AT A REGULAR MEETING OF THE DEVELOPMENT REVIEW COMMITTEE OF THE COUNTY OF JAMES CITY, VIRGINIA, HELD IN THE BUILDING C CONFERENCE ROOM AT 4:00 P.M. ON THE 28th DAY OF JULY, TWO THOUSAND FOUR.

SP-98-04 Warhill Green

Date: August 13, 2004
To: Matthew Arcieri, Planner
From: Timothy O. Fortune, P.E. - Civil Engineer
Subject: SP-098-04, Warhill Green (Construction Plan)

ENVIRONMENTAL DIVISION REVIEW COMMENTS
GREENSPRINGS WEST PHASE VI
COUNTY PLAN NO. S - 59 - 04
July 26, 2004

DETECTOR CHECK VALVE ASSEMBLY FOR FIRE SUPPRESSION SYSTEMS

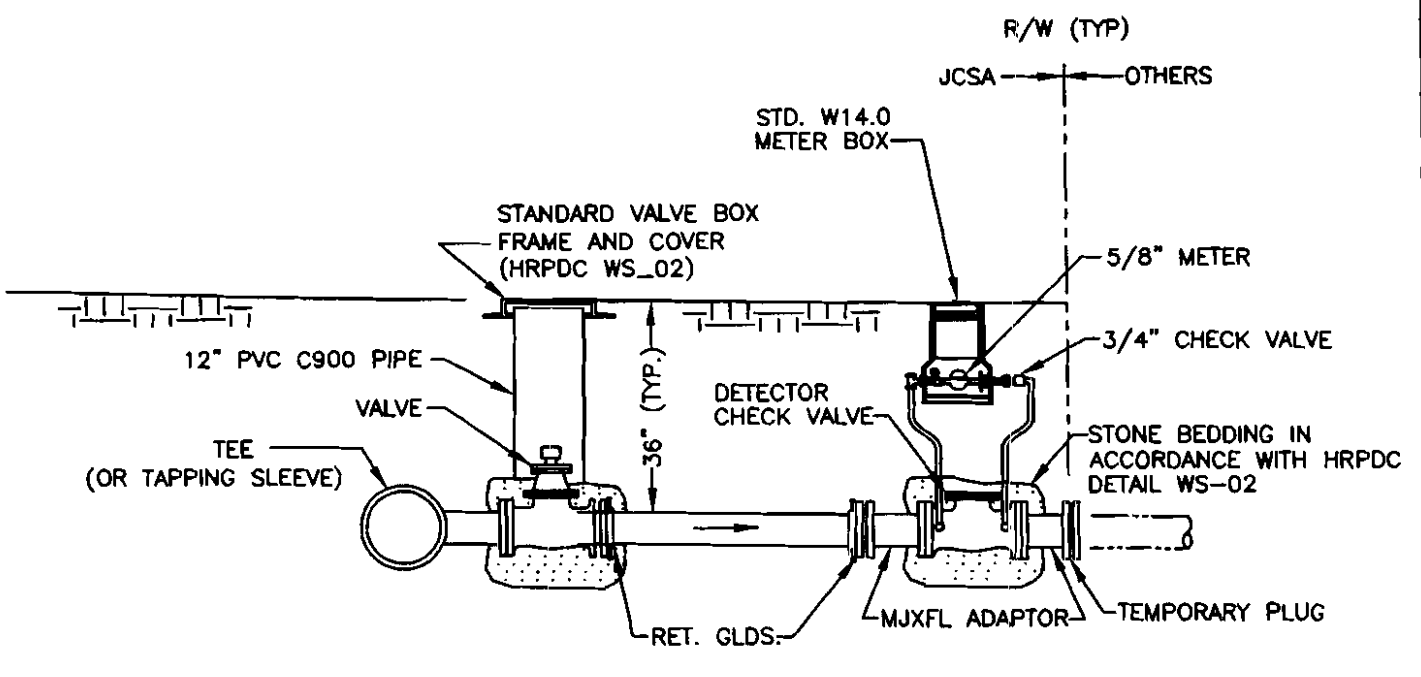
1. Since the proposed fire supply system will be private, a backflow prevention device (low hazard condition) shall be provided on the line. Attached is a "Detector Check Valve Assembly" detail which can be used for backflow prevention. The detector check valve shall be located at the right-of-way line. This will delineate the end of JCSA's responsibility for the fire supply line. The detail shall be modified by the Applicant to show the 5/8" meter located outside of the paved area, preferably adjacent to the proposed 2-inch master meter. Water meter location and size shall be clearly identified on the site plan.
